Daylight and Sunlight

Centric Close

Re: Centric Close, Planning Application Reference: 2016/6891/P – Daylight/Sunlight and Overshadowing

Please find below our response to the Daylight/Sunlight and Overshadowing objection letter received from Anstey Horne dated 23rd March 2017 on behalf of 19 and 23–29 Oval Road.

Figure 03 - Window Map depicting W1/1099

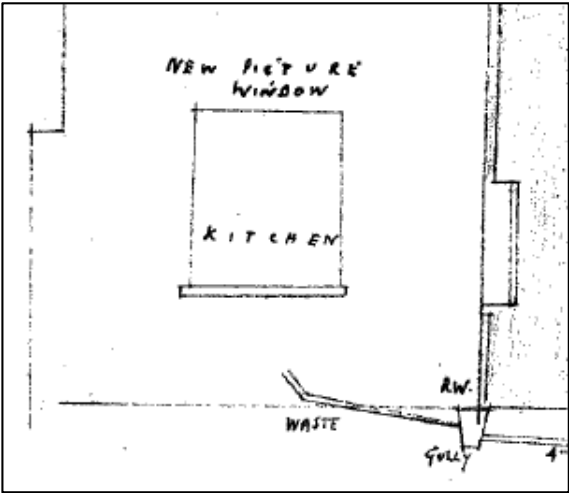
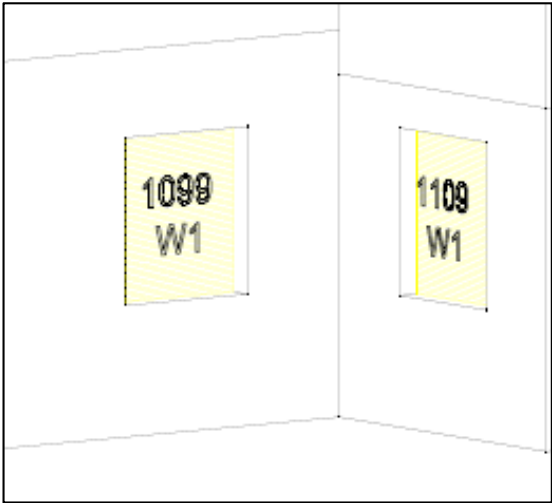
Windows in the rear elevation of 19 Oval Road were modelled using plans obtained from the Camden Local Authority Online Planning Portal. Window W1/1099 that Anstey Horne have referred to was modelled from elevation plans that were obtained from planning application reference: J11/1/11982A;

Figure 02 below illustrates the window on the elevation plan and Figure 03 the corresponding window map depicting W1/1099.

As access was not obtained to the property and the window could not be seen from aerial or site photography due to dense tree coverage, the window was modelled from the plans available. Additional information has now been made available by Anstey Horne as they were able to gain access to 19 Oval Road subsequent to our modelling and analysis being undertaken. If this window were to be modelled as the double French doors then this would improve the quantum of light in the room as the aperture would be larger.
